To  
Subject ECC Attachment Z-1

**ATTACHMENT Z-1**

**ENVIRO-CHEM SUPERFUND SITE  
ZIONSVILLE, INDIANA**

April 2007

Figure  
**3**

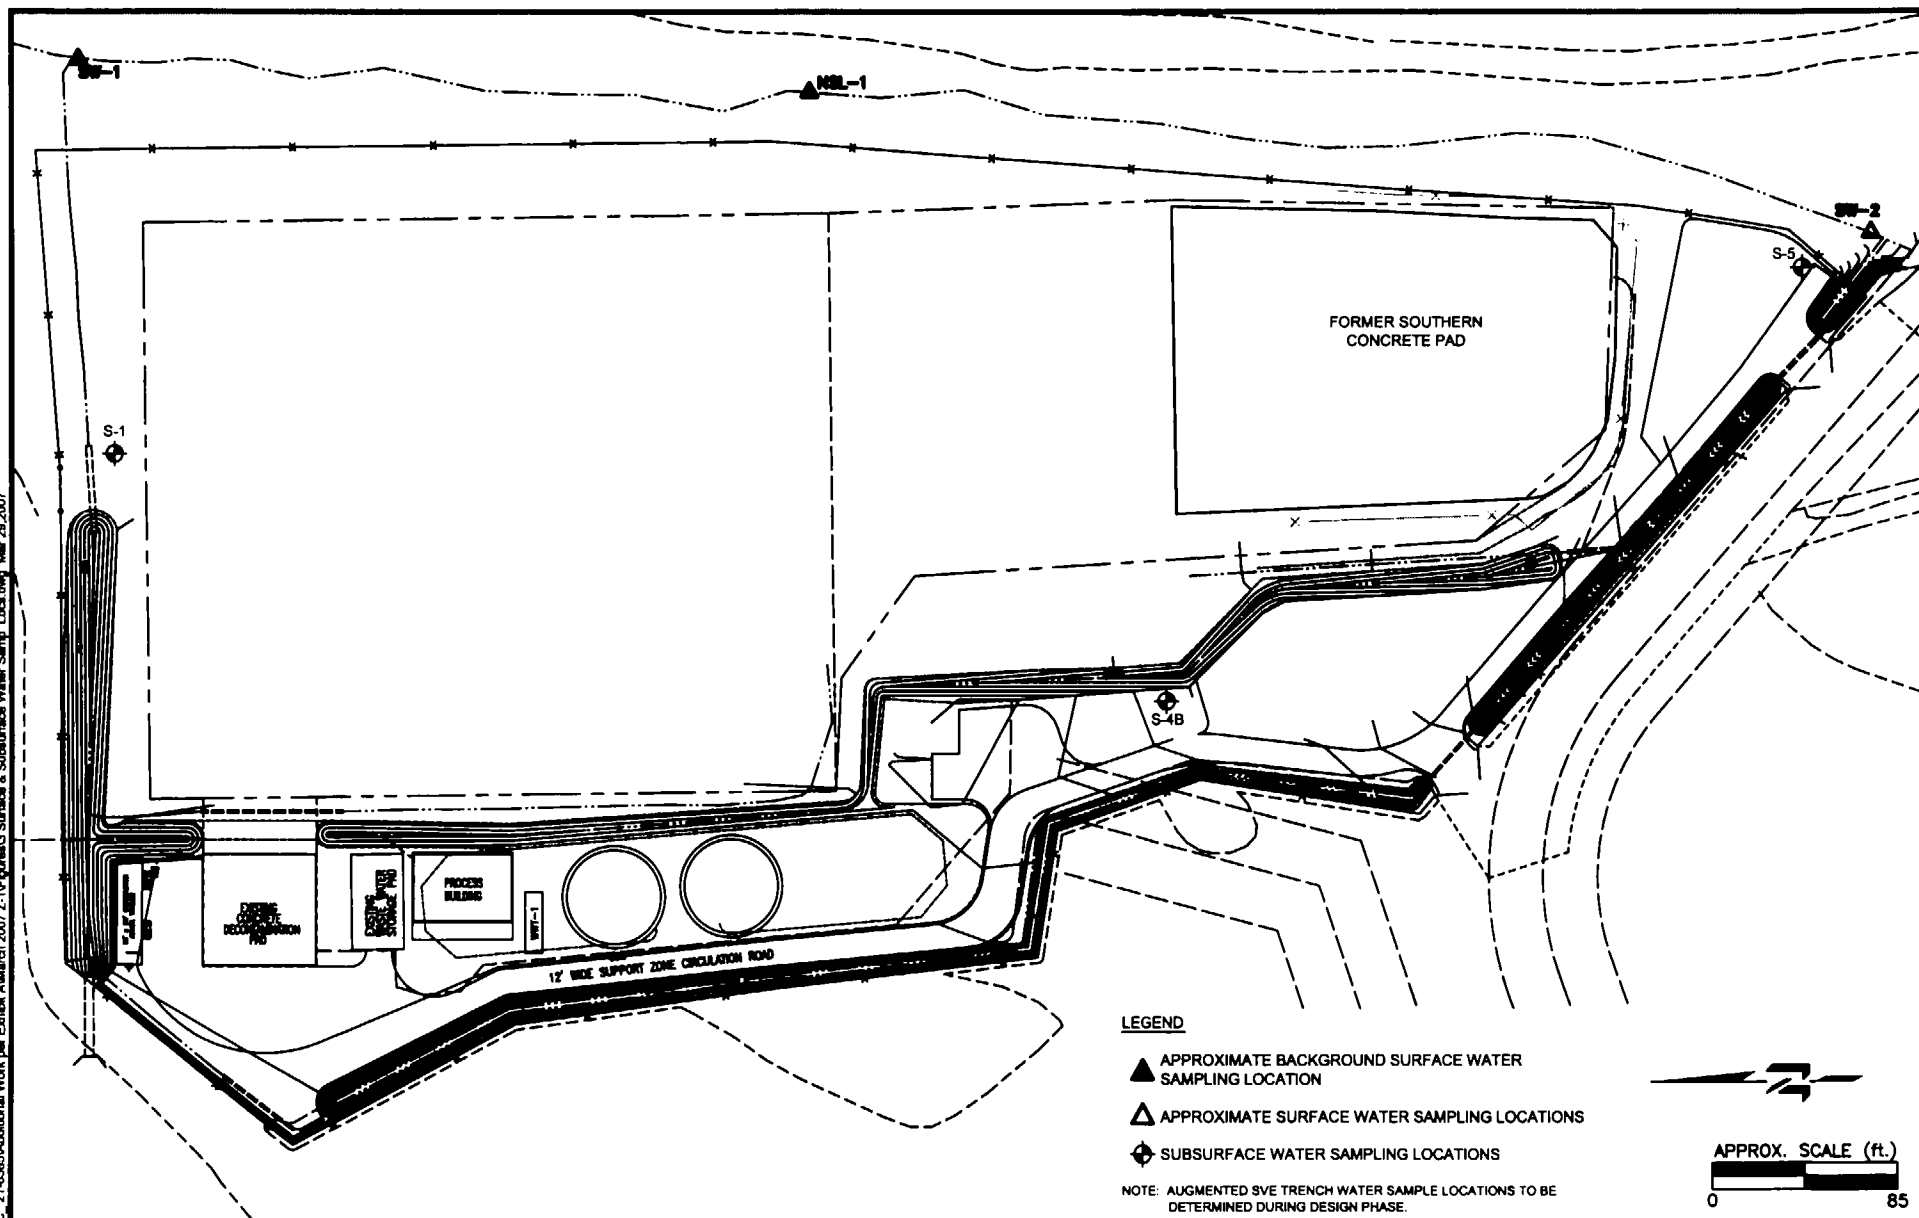
3. Figures 3, 4, and 5 have been deleted, and the former Figure 6 has been renumbered Figure 3. Figures 3, 4, and 5 contain design details that are included in the Design Report; therefore, they have been removed from this Attachment Z-1.

Construction related activities at the ECC Site during 1998 and 1999 may have damaged monitoring well S-4A. As a result, a new well (S-4B) will be installed approximately 50 feet to the south (downgradient) of S-4A, in a low traffic area to be agreed on by the parties. The proposed location for S-4B is shown on Figure 3.

discharge location within Unnamed Ditch, as depicted on Figure 3. Additional samples may be collected at the discretion of the ECC Site Trustees.

During operation of the augmented SVE trench system, the subsurface water within the augmented trench system and wells S-1, S-4B, and S-5 will be monitored on a semiannual basis. Wells S-1, S-4B, and S-5 are depicted on Figure 3. Additional samples may be collected at the discretion of the ECC Site Trustees.
